CONSTRUCTION PLANS FOR

NOR ESTE MANOR SUBDIVISION

DRAINAGE, GRADING, PAVING AND UTILITY
IMPROVEMENTS

NOTE:
SHEETS AFFECTED BY CHANGE ORDER #1
AS INDICATED

TITLE
NOR ESTE MANOR
JULIAN ROBLES ST. N.E. STA. 0+00.00 TO STA. 5+27.51
CORONA AVE N.E. (CUL-DE-SAC) STA. 0+00.00 TO STA. 1+05.00
UTILITY PLAN AND PROFILE

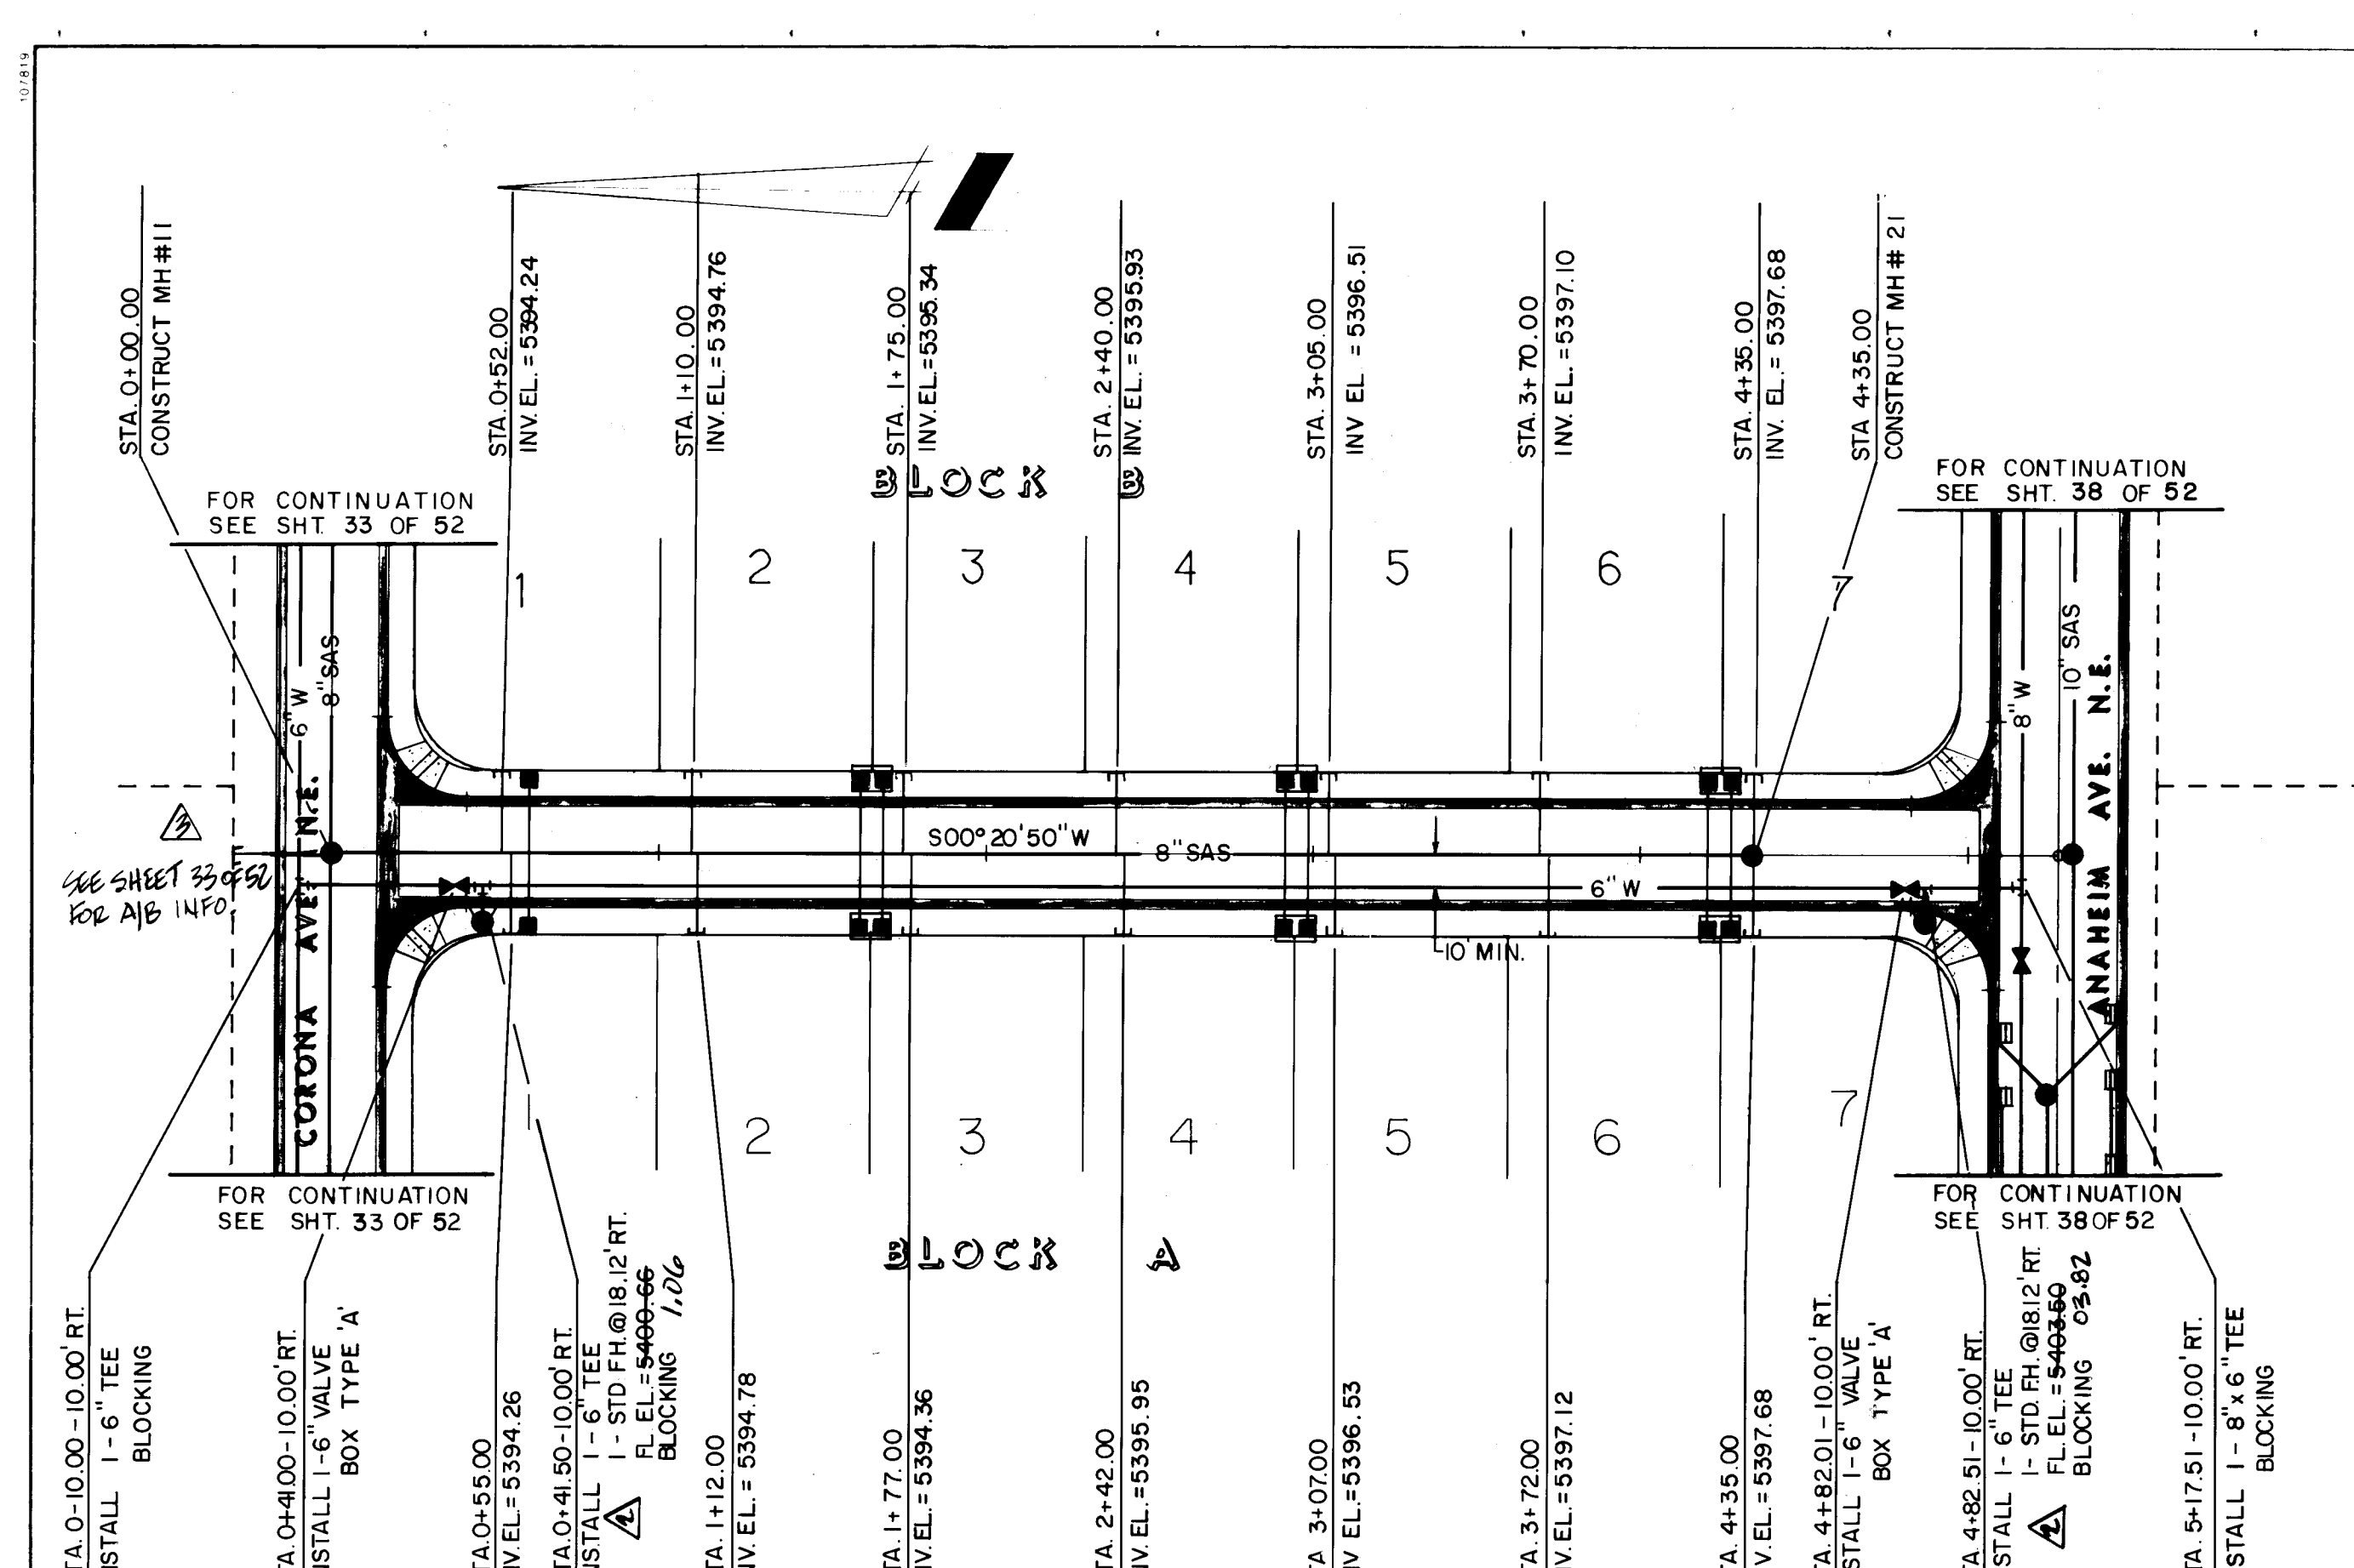
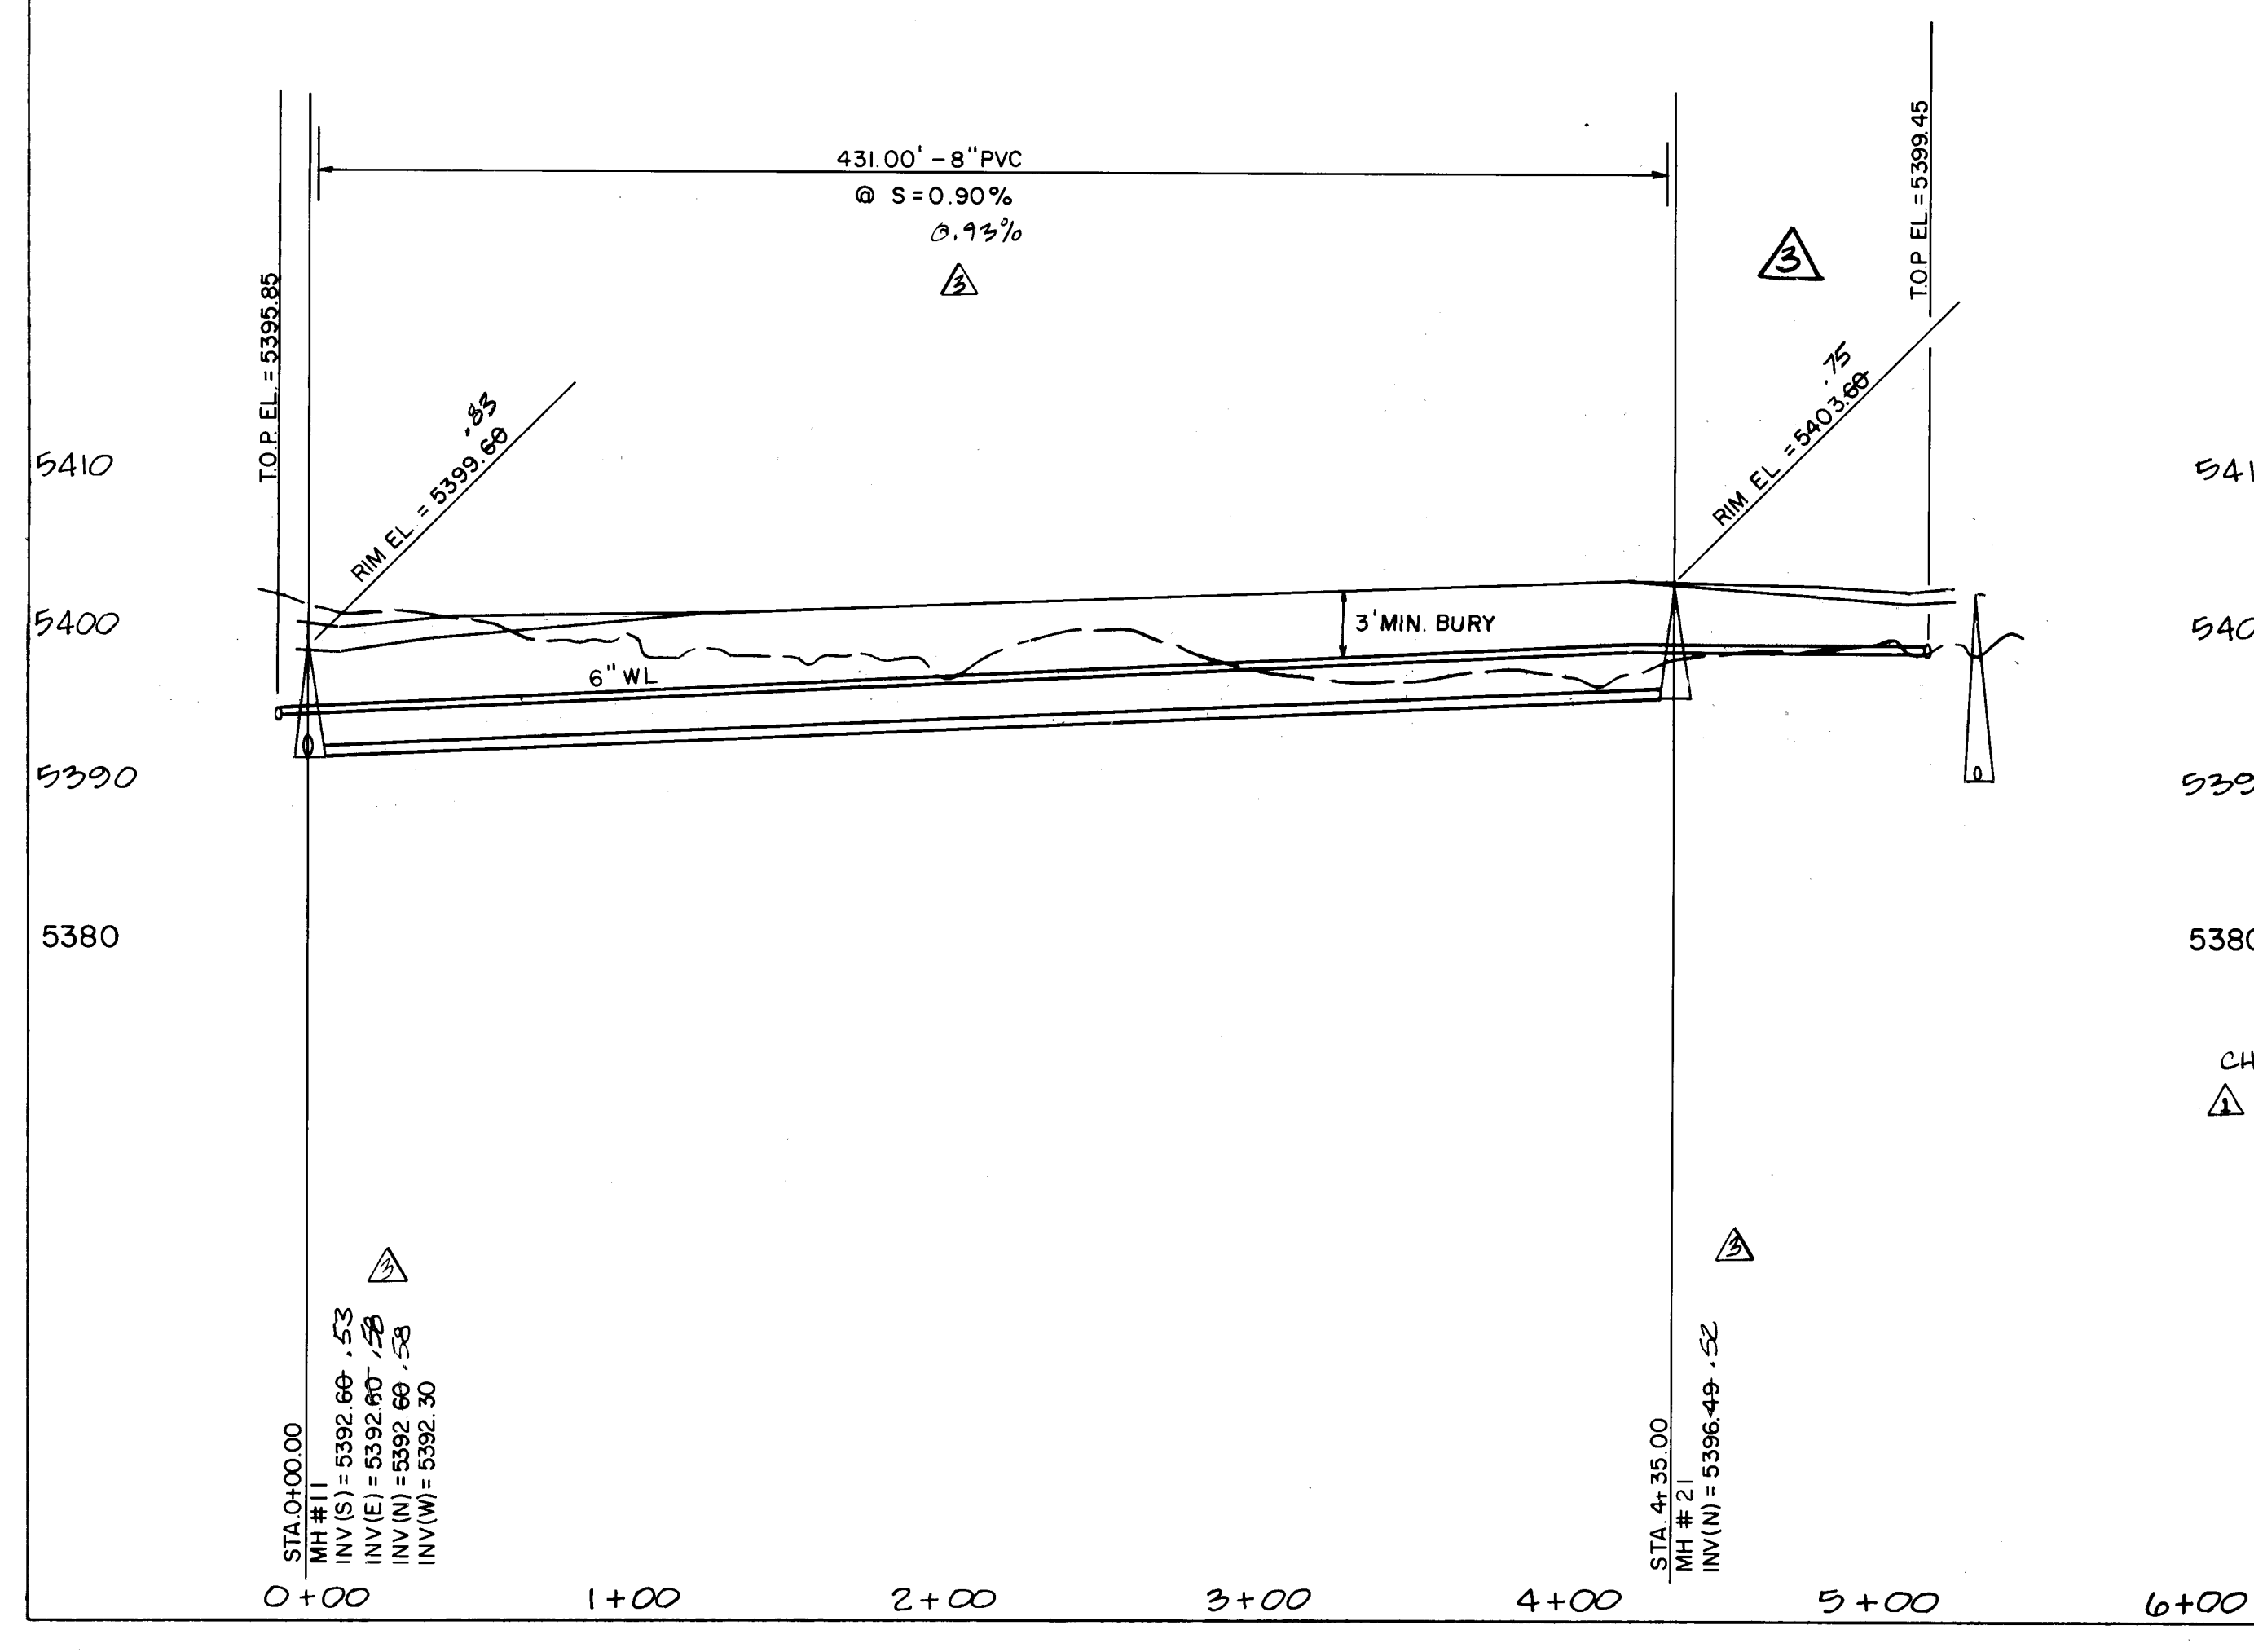
CHANGE ORDER NO. 1
REVISIONS
REGRADE JULIAN ROBLES AND CORONA SEWER/WATER
